August 8, 1975

DISPLAY/CONTROL BOARD CAPACITOR MODIFICATIONS

8800 GROUNDING MODIFICATION

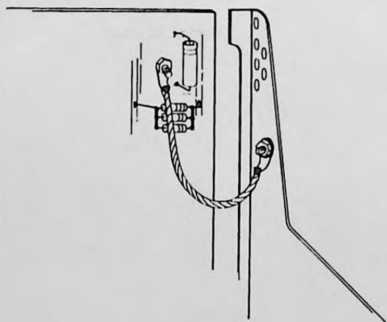
THE FOLLOWING CAPACITORS ON THE DISPLAY/CONTROL BOARD ARE TO BE CHANGED TO THE VALUES INDICATED BELOW:

C7 should now be 0.01 μ f

C8 should now be 0.1 μ f

THESE SUBSTITUTIONS ARE TO IMPROVE THE OPERATION OF THE ALTAIR'S DEPOSIT CIRCUITRY.

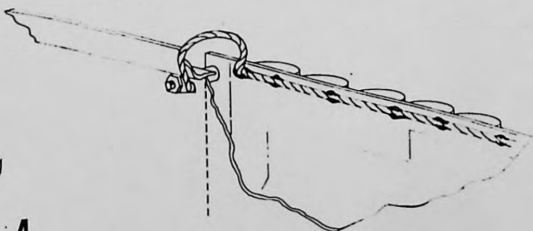
- () Prepare another length of 1/8 inch braid in exactly the same manner as the first piece.
- () Connect this braid between the card rail towards the back of the unit on the side opposite the transformers and the chassis as shown in the drawing below.

- () The 1/4 inch braid is to be soldered directly to the PC land on the bottom (non silk-screened) side of the power supply board. Solder this braid in place along its entire length between the negative side of C1 and the positive side of C14. (see drawing below)
- () Prepare a 4 inch length of 1/8 inch braid by attaching a solder lug to one end.
- () Solder the end opposite the lug on the 4 inch length to the end of the 1/4 inch braid beneath capacitor C1 as shown in the drawing below. The end of the 1/8 inch braid with the solder lug will be attached to the bottom side of the cross member with the same screw which mounts the closest corner of the power supply board.

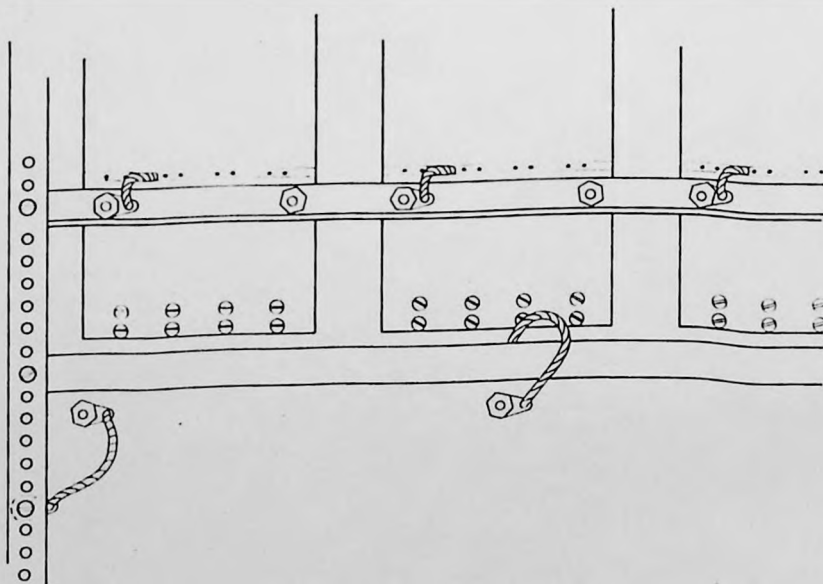
() Connect this length of braid between the cross member on the side opposite the transformers and the chassis as shown in the drawing below.

NOTE: The drawing below also shows the 4 inch length of braid from the power supply board properly attached to the cross member as previously instructed.
